Questions regarding 560 and 770 Winston Churchill from Residents and delegations to be answered.

This is a written submission dated June 26, 2022 to the Members of Council for the Town of Oakville from the following parties:

- 11087258 Canada Inc., 560, 570 and 580 Winston Churchill Blvd. (formerly 560 Winston Churchill Blvd.), SP.1601.028/01, Ward 3
- 772 Winston Churchill Limited Partnership (c/o IBI Group), 700 and 750 Winston Churchill Blvd. (formerly 772 Winston Churchill Blvd.), SP.1601.029/01, Ward 3

Figure 1. Predicted Mitigated Nighttime Sound Level Contours, Non-Impulse Sources, Leq1hr (dBA).

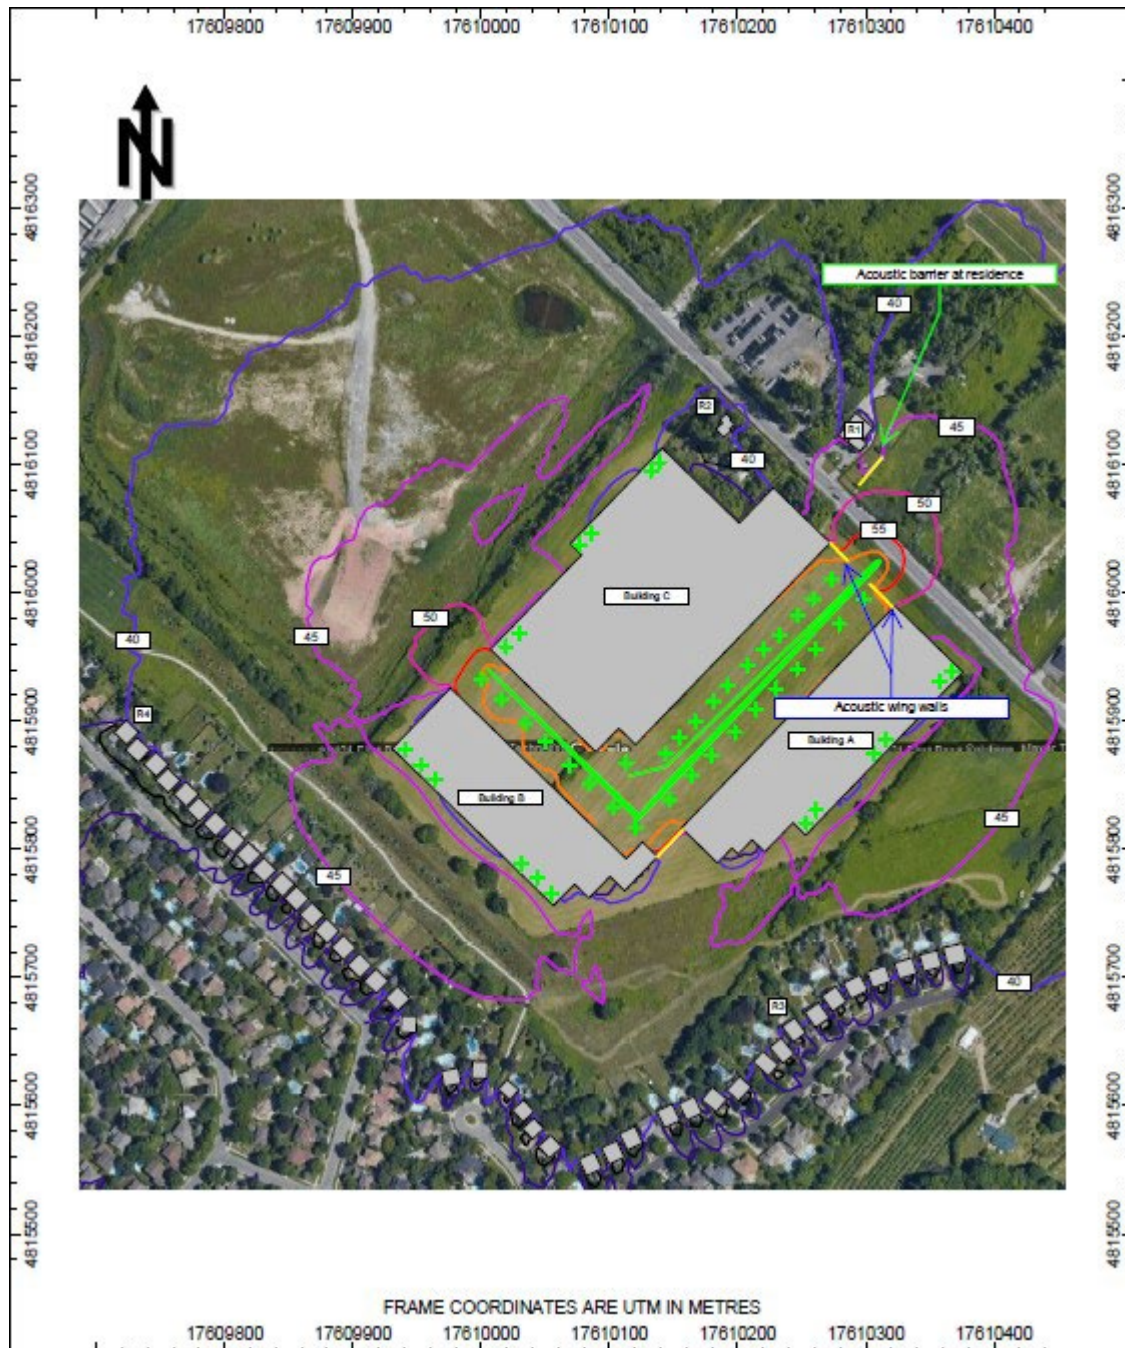
- With reference to the Noise Feasibility Study by HGC,¹ we note the following:
 - Figure 6 shows the predicted mitigated nighttime sound level contours representing 45 dBA (shown by the pink lines),² which is the limit between the hours of 23:00 – 07:00 (according to By-law 2008-098).³ We reproduce Figure 6 as Figure 1 for ease of reference. Figure 1 shows that Receptor 3 (shown as R3 to the south) and Receptor 4 (shown as R4 to the west) are below the threshold of 45 dBA, however, these receptors are positioned farther away from the sources of sound. The sound level contours indicate that the residential properties closest to the warehouses could be exposed to noise levels exceeding 45 dBA. We are hopeful that the Members of Council will not approve any projects where the supplied data suggest non-compliance to the by-laws.

- In addition, parts of the Town of Oakville trail located between the residential properties and the warehouses could be exposed to even higher sound levels.

- As with all modelling efforts, there are assumptions required. Therefore, to safeguard against noise exceedances, the modelled values should be below the limits set by the by-laws.

- The peer review conducted for 560 Winston Churchill Blvd. by Dillon Consulting Ltd. (Dillon) indicated that the Noise Feasibility Study should be updated to detail background sound levels, clarify heavy vehicle totals/percentages, and include back-up alarms.⁴ It also states that a stationary noise assessment should be completed that incorporates **both** (emphasis added, namely 560 Winston Churchill Blvd. and 772 Winston Churchill Blvd.) properties to quantify the cumulative impacts.⁵ This would potentially extend the sound level contours described above (see Figure 1) to extend further into the residential properties.

Night time criteria applies at the façade of the building, not the property line. The Figure appears to conform. Guidelines aren't applied to trail areas, as these are not classified as sensitive.

Town Staff and their Peer Reviewers have had a chance to review the report and have provided comments where appropriate. Comments included in the peer review of the Noise Study were minor, and appropriate responses have been provided to the peer reviewer and the municipality in our updated report.

Figure 3. Detailed capacity analysis data extracted for Winston Churchill Boulevard & Beryl Rd. in 2021, 2022, and 2027.

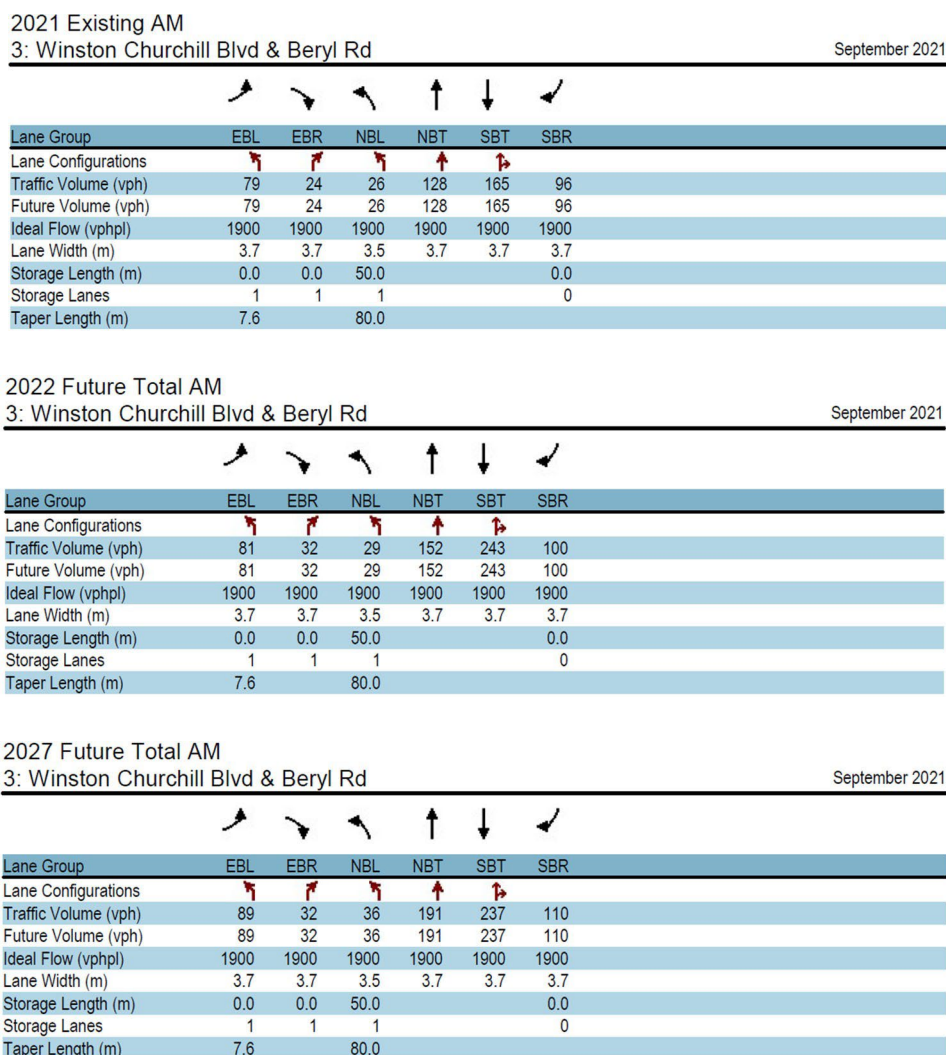
-
- It is difficult to reconcile the vehicle movements presented by C.F. Crozier & Associates Inc. (Crozier) for 560 WCB. Crozier's Table 5 is reproduced below as Table 1¹⁰ and presents the total net generated trips as 108 in the A.M. peak hour. It is reasonable to assume that many of these trips will be southbound on WCB after Beryl Rd.

- Therefore, the total number of new trips from both properties is estimated to be 108 + 113 = 221. Noting that these warehouse complexes are roughly the same size, the total number of truck trips in the A.M. peak hour for both properties is estimated to be 22 x 2 = 44.
- We have reviewed the detailed capacity analysis of the WCB/Beryl Rd. data for 2021, 2022, and 2027¹³ in the 2021 Crozier Report and grouped some of the annual data for ease of reference in Figure 3. The number of southbound trips on WCB after Beryl Rd. are calculated to be as follows: 24 + 165 = 189 (2021), 32 + 243 = 275 (2022), and 36 + 237 = 272 (2027). The increase between 2021 to 2022 is 86 trips and is less than the 221 trips mentioned previously. There is no explanation for the discrepancy in these figures.

Trucks are not permitted on Lakeshore Rd, and would be required to head northbound.

Traffic was grown at a rate that was approved by the Municipality and Regions, and confirmed acceptable by the Peer Reviewer.
